STAFF QUESTIONS - for October 14, 2020

**Subject: Preliminary Review of Traffic Study – Proposed 7-Eleven Convenience/Gas Station,  
306 Boston Post Road, Darien, Connecticut**

15 - 2020 7 eleven

TREES NEAR  
PROPOSED  
PYLON SIGN

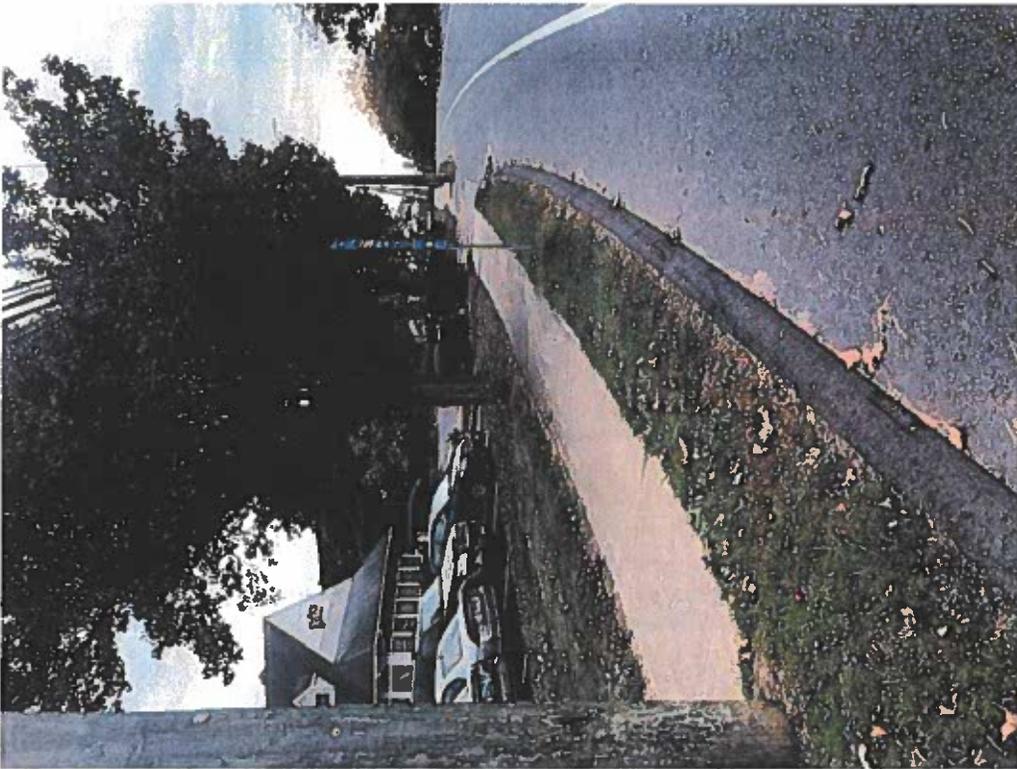
3. As of October 7 the applicant advised that the proposed flagpole near the proposed pole sign is being removed from the plans.
4. As of October 7 the applicant did not answer if the existing trees near the proposed pylon sign location would be preserved. They are approximately identified on the attached Staff prepared site information plan.

And will the existing maple and pear trees near the proposed pylon sign be preserved.

HANGING STYLE SIGN  
ON NEARBY STATION

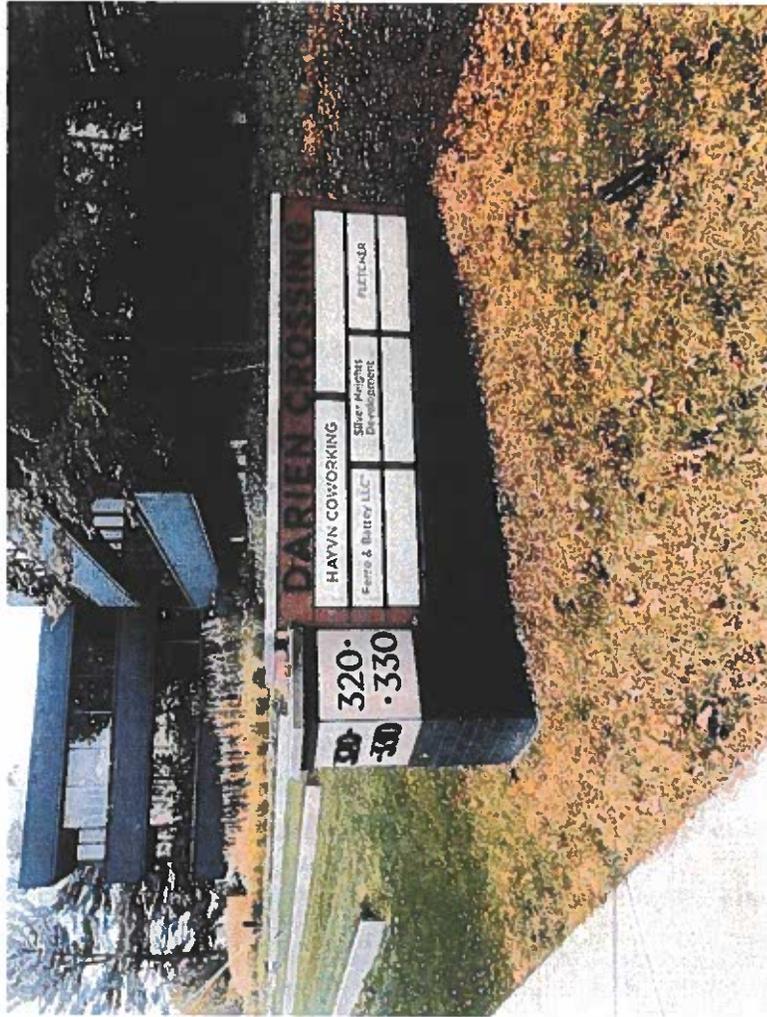
5. It turns out the nearby Mobil sign (photo enclosed) is identified as a Hanging Sign in the current regulations. And that style, in lieu of any wall sign, can be in the front setback space. However, the fuel price sign cannot be closer to the road than the gas island, just like a pylon/pole sign. The adjacent office building has a monument style sign (photo enclosed). Would a Mobil like hanging sign, or a monument style sign, be more acceptable?

THIS KIND OF SIGN IS CONSIDERED  
A "HANGING SIGN" IN THE CURRENT  
REGULATIONS - LIMITED TO 12 SQUARE  
FEET, 9' HIGH & IN LIEU OF A WALL  
SIGN BUT NO SETBACK
